# Memo

**Subject: Plan Modification: Clause 20A modification to Auckland Unitary Plan**

<b>Rule or Section of Unitary Plan</b>	NA
<b>Subject Site (if applicable)</b>	27 to 41 Johnstone St, Point Chevalier, Auckland
<b>Legal Description (if applicable)</b>	
<b>Nature of change</b>	<p>A clause 20A modification is required to correct the mapping of the indicative coastline in the AUP.</p> <p><b>Discussion</b></p> <p>The owner of 27 Johnstone St has sent council an email query about the location of the indicative coastline to the south of their property. A surveyor has prepared a plan establishing that the location of mean high water springs (MHWS) is at the stormwater pipe outfall visible from Oliver St. The AUP indicative coastline shows the coastline as being six properties to the east (at 41 Johnstone St), across the mouth of a small inlet.</p> <p>Less recent survey plans for 31 and 33b Johnstone St also show that MHWS has been surveyed as being on the bank of the creek to the east of the stormwater outfall. The surveys also show that since the 1911 survey of mean high water mark, there was 45m<sup>2</sup> of accretion at 31 Johnston St and small areas of accretion and erosion at

**Attachment 2 Annotated map of the amendment to the indicative coastline**

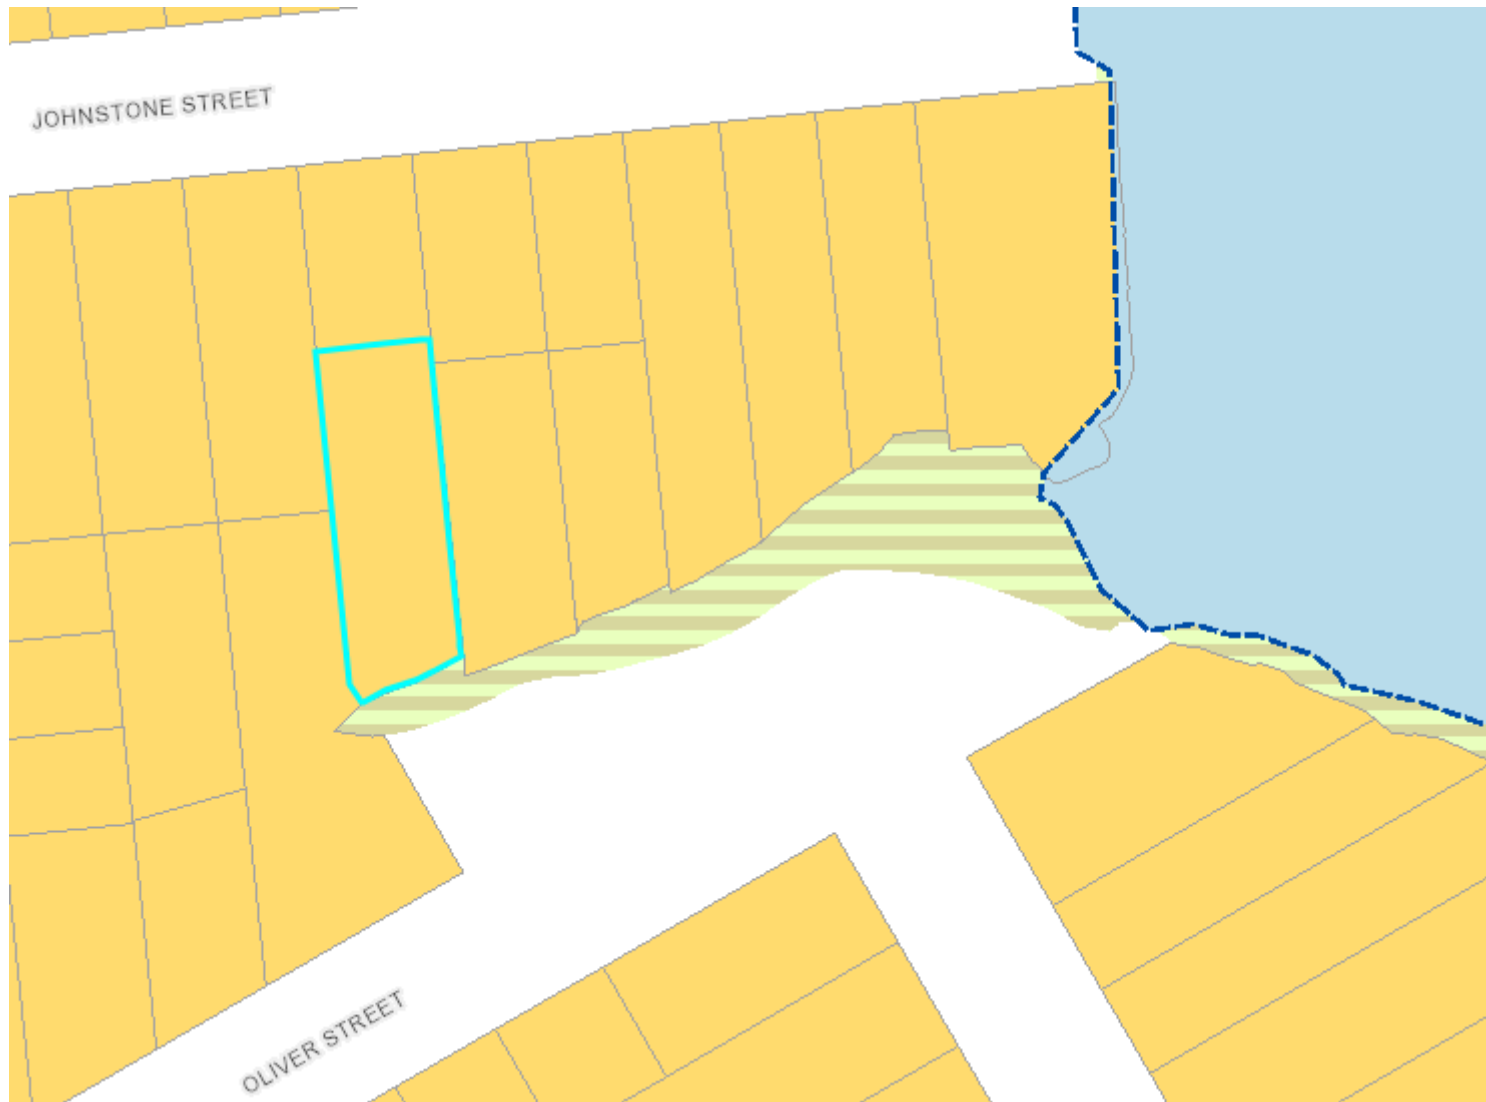
<p>Transition Zone which is the zone applied where the current coastline does not align with the zoning extent of legacy district plans.</p> <p>I have considered whether the inlet to the east of the stormwater pipe should be treated as coastal marine area (CMA) or river. The current location of the indicative coastline is correct if this is a river.</p> <p>The RMA definition of CMA states that where the line of MHWS crosses a river, the landward boundary of the CMA at that point shall be whichever is the lesser of—</p> <ul style="list-style-type: none"> <li>(i) 1 kilometre upstream from the mouth of the river; or</li> <li>(ii) the point upstream that is calculated by multiplying the width of the river mouth by five.</li> </ul> <p>If this case is a river, the CMA inland boundary (i.e. upstream by five times the width) would be part way between the current indicative coastline and the stormwater outlet.</p> <p>There is no stream upstream of the stormwater pipe outlet. This means that the waterway should be treated as a small inlet of the CMA, and not a river. Consequently, the location of the indicative coastline should follow the line of MHWS established by surveys.</p> <p>I have confirmed this approach with Alan Moore and Stephen McKenzie in the Resource Consents Department.</p>

<p>The use of “will shift” in the last part of this explanation means that MHWS is applied as being in the location found by the site-specific survey for any relevant consent application, not that the indicative coastline will be moved whenever a MHWS survey is done. There is no need for the indicative coastline to be amended in the AUP before the site-specific survey information is applied in a consent process.</p> <p>The amendment to the indicative coastline means that the area of the inlet will be changed from Coastal Transition Zone to General Coastal Marine Zone. The approach set out in F1.1 means that the change in zoning on the map does not change the provisions that would be applied to a consent process. The location of MHWS at a site determines the zoning that applies.</p>
<b>Changes required to be made (text/in-text diagrams)</b>	NA
<b>Changes required to be made (maps)</b>	Amend the indicative coastline in the GIS Viewer to follow the small inlet at Oliver St Point Chevalier between the current coastline and the stormwater pipe outfall structure.
